Comment #147, #169: Problems of high DFE coefficients

Yasuo Hidaka
Fujitsu Laboratories of America, Inc.

September 16-18, 2015

Effect of fp1 on COM and BER for 3m Cable

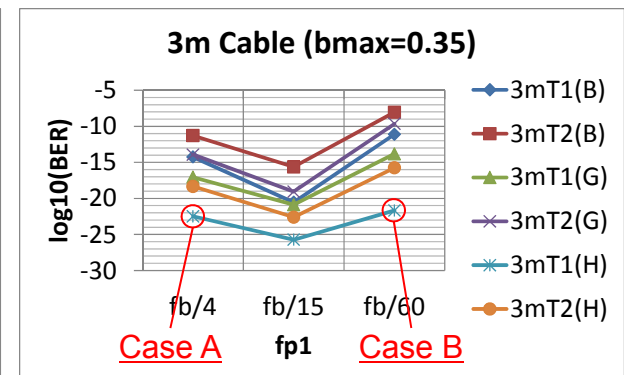
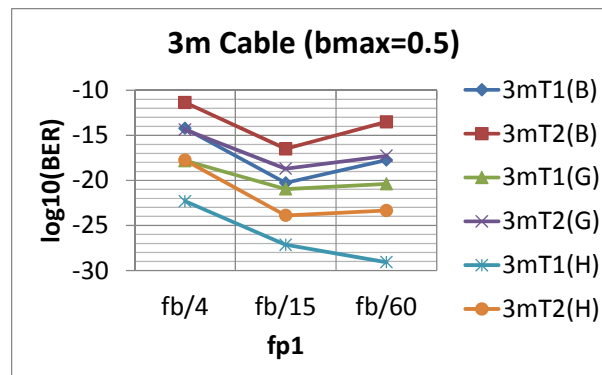
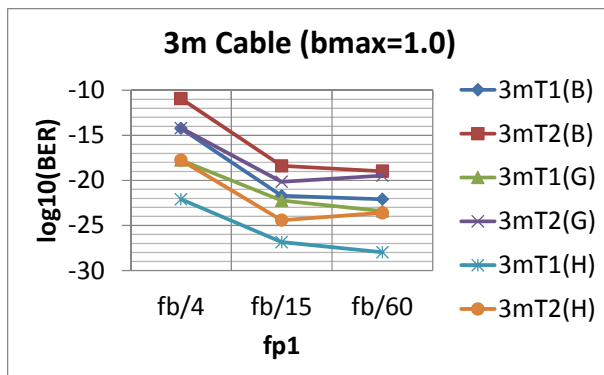
■ COM and BER are roughly consistent when bmax=1.0

■ COM and BER are very inconsistent when bmax=0.5 or 0.35

■ Although BER is improved or same, COM is often largely degraded

Effect of fp1 on COM and BER for 5m Cable

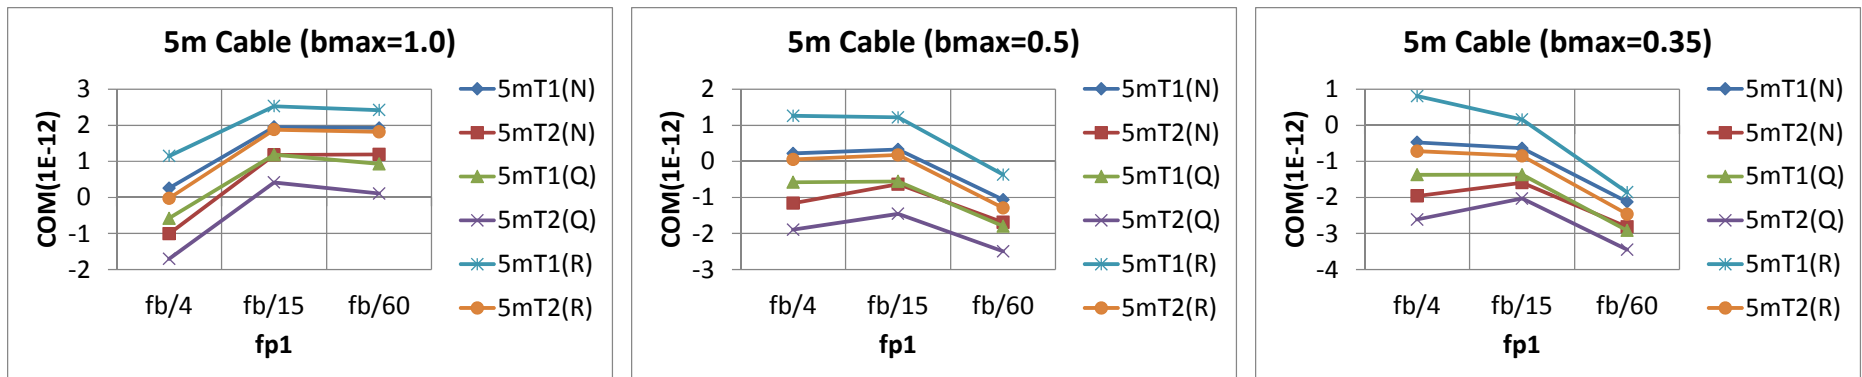
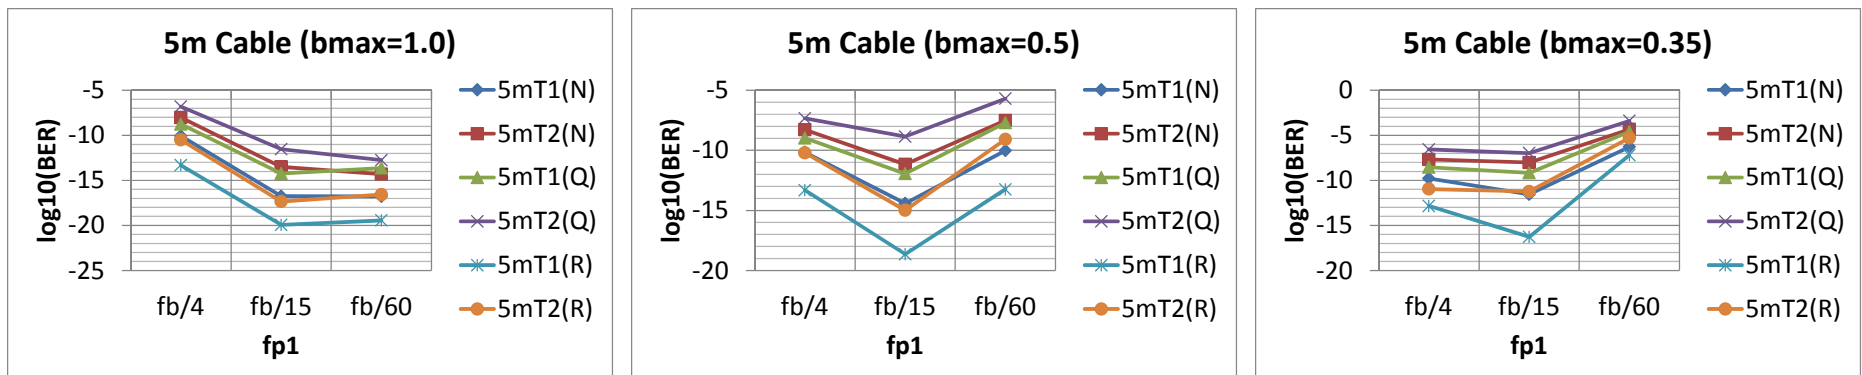
■ COM and BER are roughly consistent when bmax=1.0

■ COM and BER are very inconsistent when bmax=0.5 or 0.35

■ Although BER is improved or same, COM is often largely degraded

Effect of b_{max} on COM

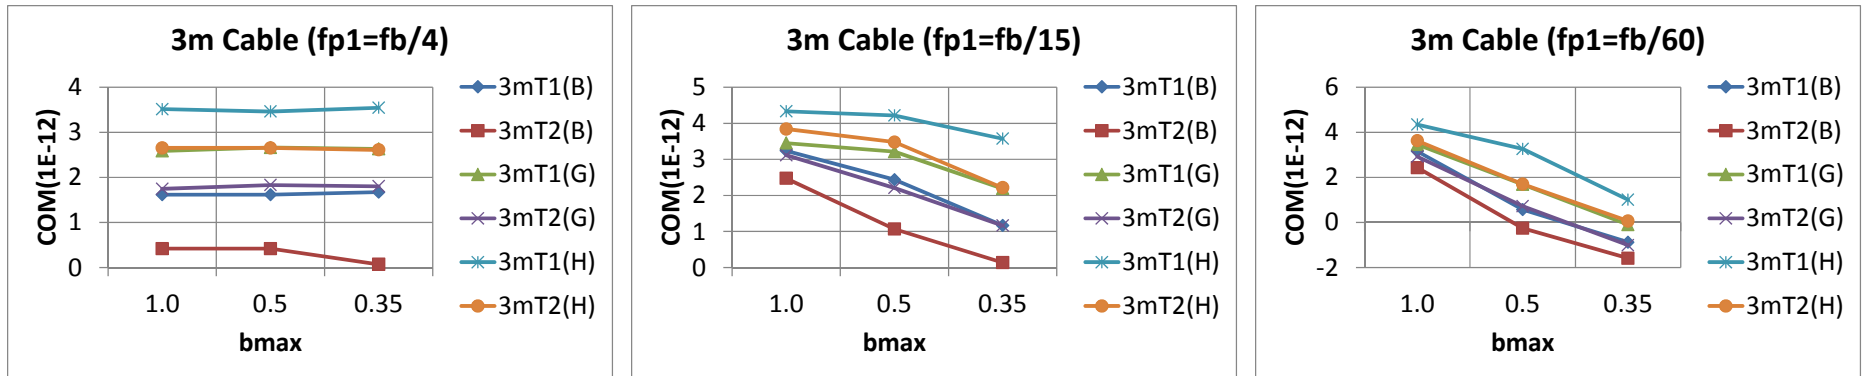
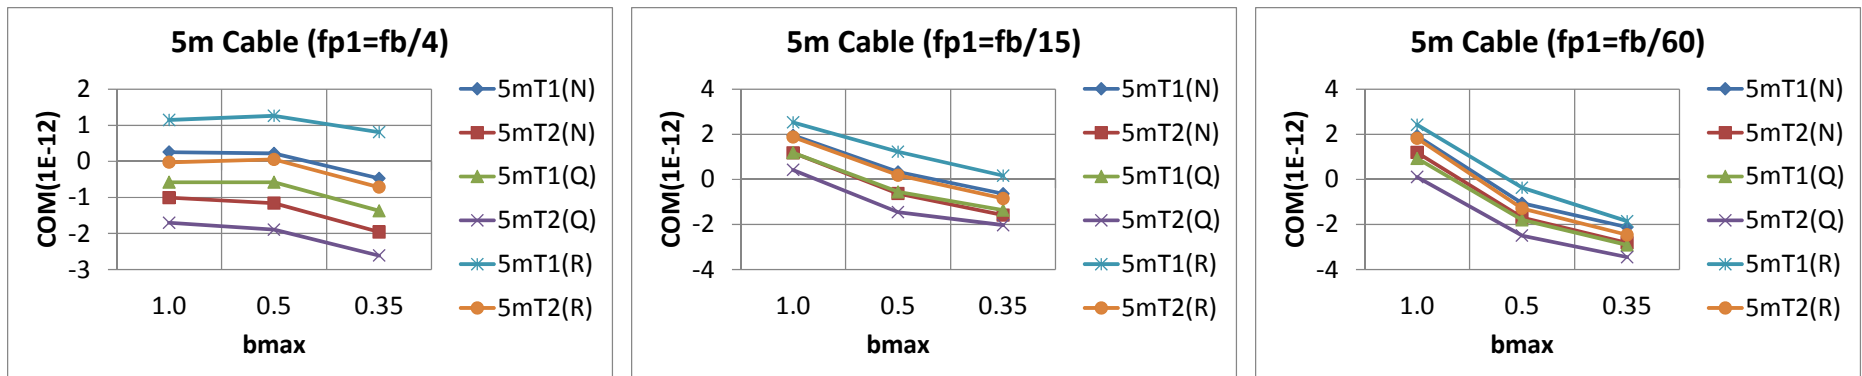
■ COM is not much affected by $b_{max} < 1$ when $fp_1 = fb/4$

■ COM is largely degraded by $b_{max} < 1$ when $fp_1=fb/15$ or $fb/60$

Effect of bmax on BER

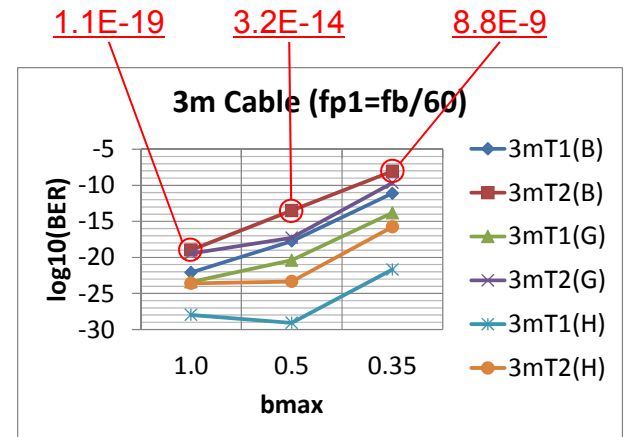
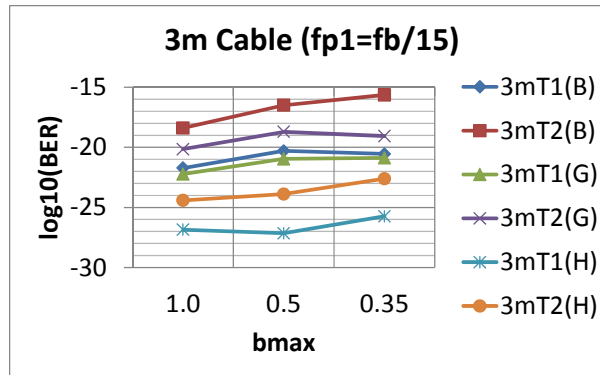
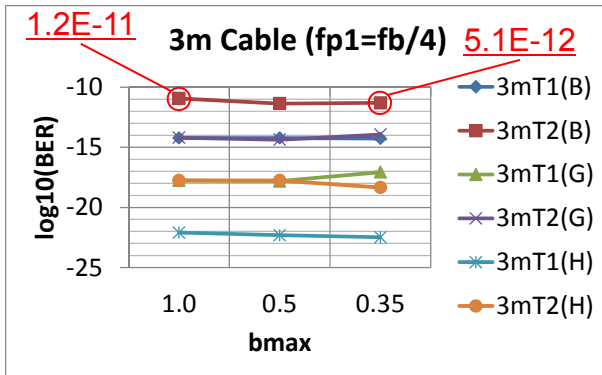
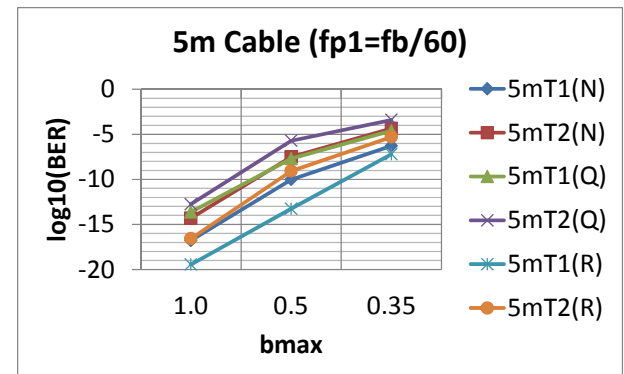
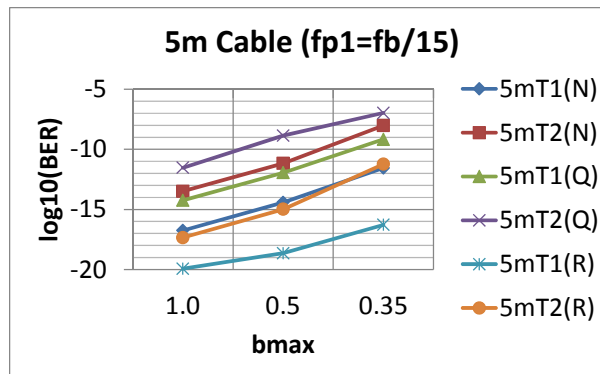
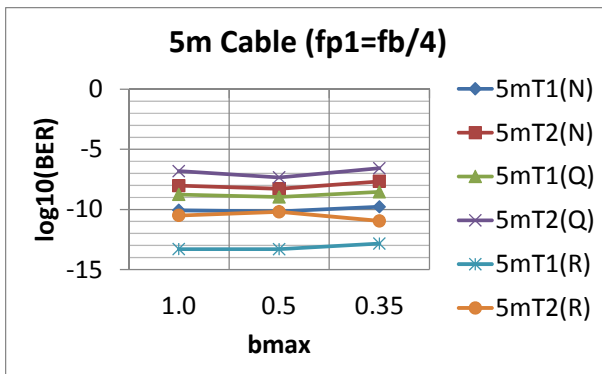
■ BER is not much affected by $b_{max} < 1$ when $fp1 = fb/4$

■ BER is often degraded by $b_{max} < 1$ when $fp1 = fb/15$ or $fb/60$

■ 3m T2(B) is thought good, but fails for test with $fp1=fb/4$ or $b_{max}=0.35$

Effect of bmax on BER in Low-Noise Condition

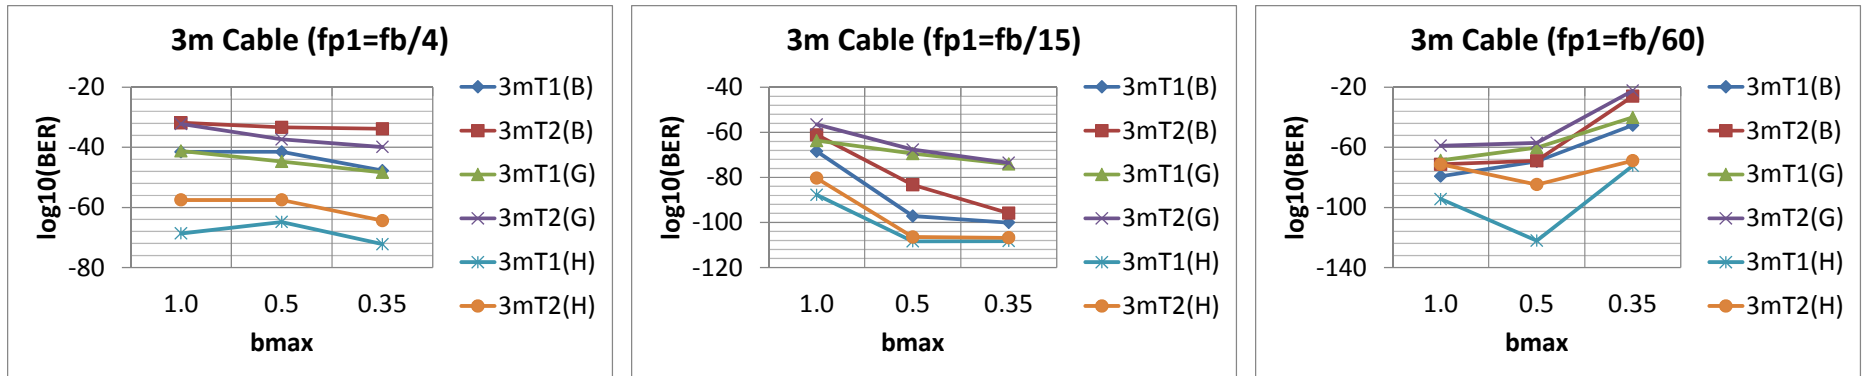
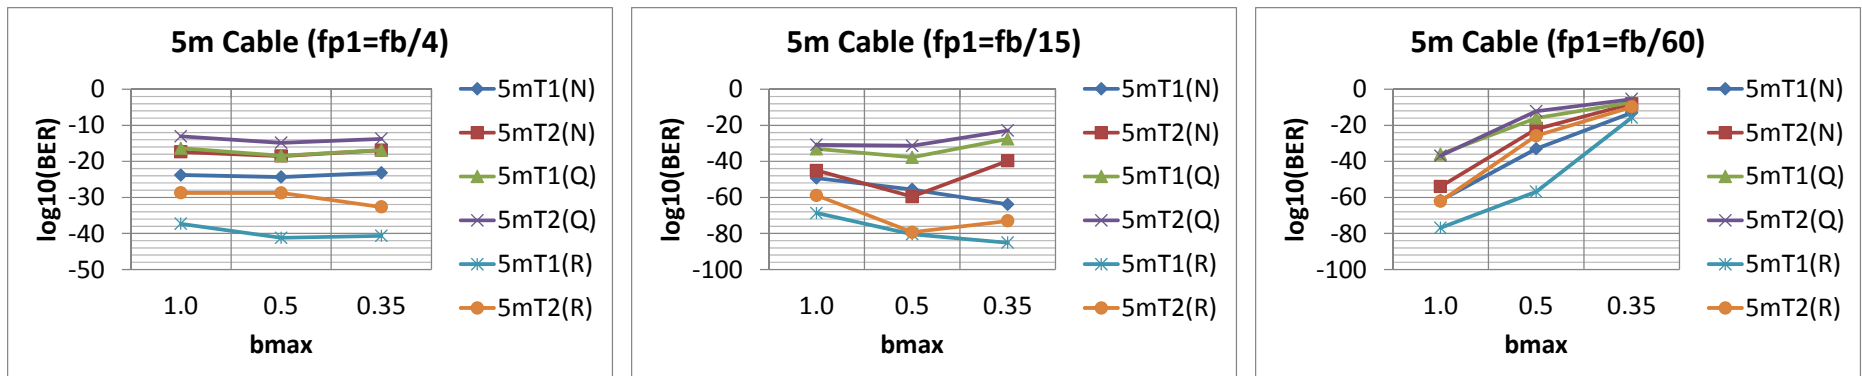
■ This is simulated without Tx output noise or Rx input noise

■ BER is often improved by $b_{\text{max}} < 1$ in this low-noise condition

■ However, this ultra low-noise condition is not realistic
